May 20, 2022 SA2022-1004

**SUBJECT**: Electric Substation Audit of PG&E's Concord Headquarters

# CPUC SUBSTATION AUDIT FINDINGS PG&E CONCORD HEADQUARTERS

Figure 2: GO 174, Rule 12 Findings 2/4

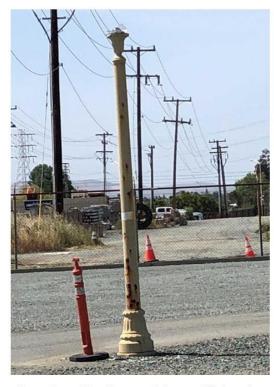
| Substations   | Findings  | Notes  |
|---------------|---|--|
| Clayton04     | Abandoned cooling water hose at the transformer bank cooling fans |  |

Clayton04: Abandoned cooling water hose at the transformer bank cooling fans
